PLANNING UNIT REPORT DEPARTMENT OF PLANNING AND DEVELOPMENT of September 11, 2006

RE: I.D. 02940, Certified Survey Map - 3333 Fieldview Lane, Town of Cottage Grove

3333 Field View Lane Certified Survey Map

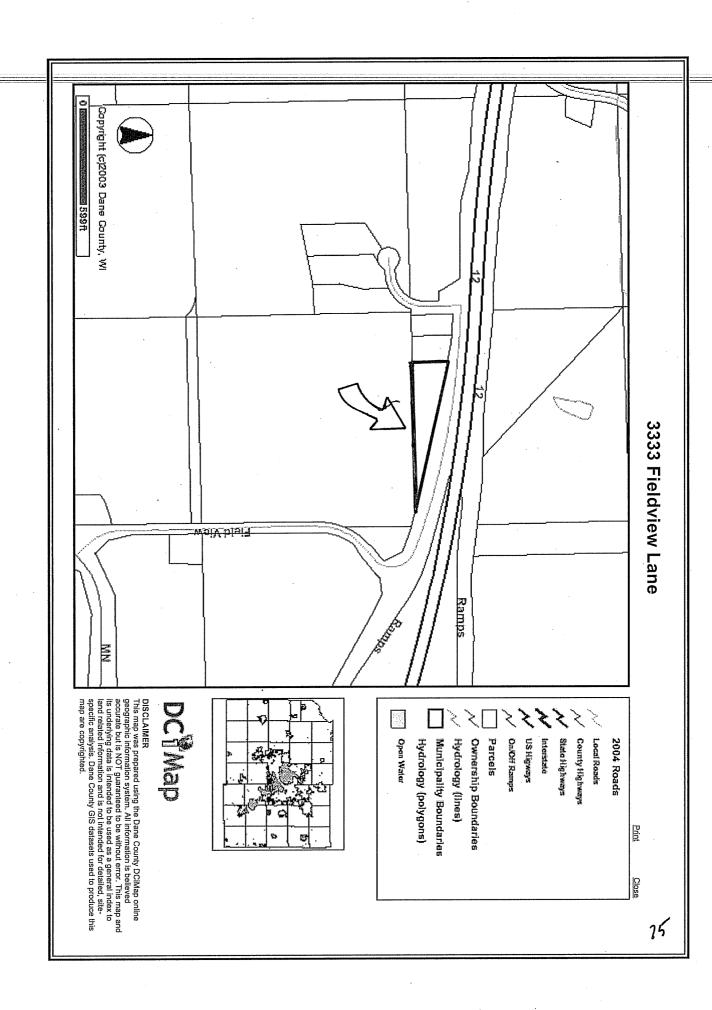
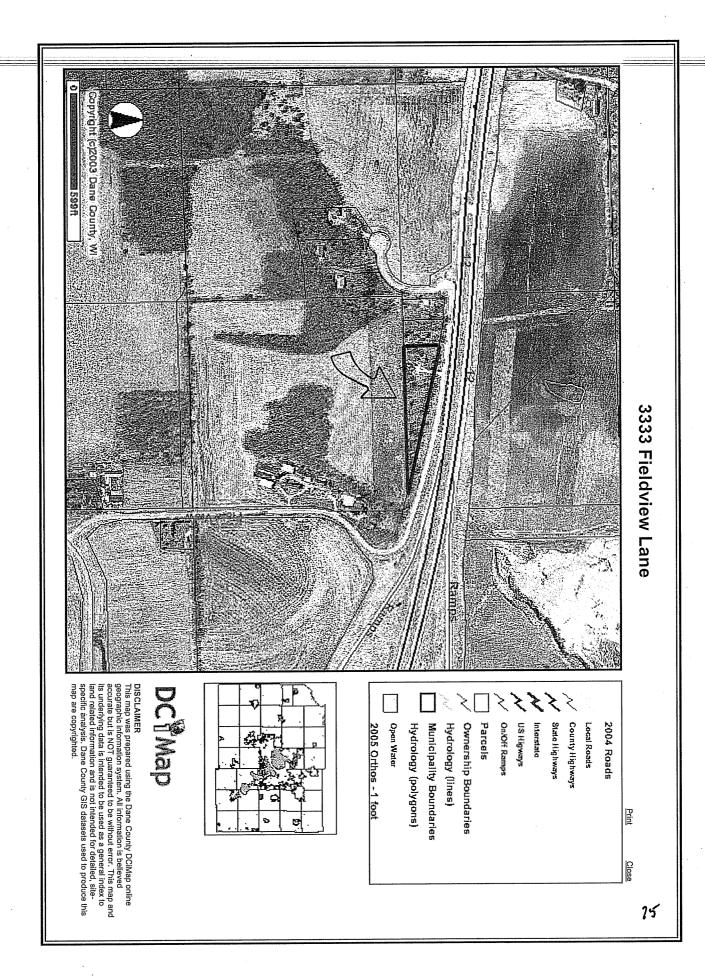
- 1. Surveyor shall certify and place a note on the face of the CSM, that there are no existing wetlands or floodplains with the CSM.
- 2. Surveyor's written certificate is missing. Distance to point of beginning S88 05 43W 294.76 is on map; written reads N89 05 43E ? ft Also map should be shown as N & E, not S & W.
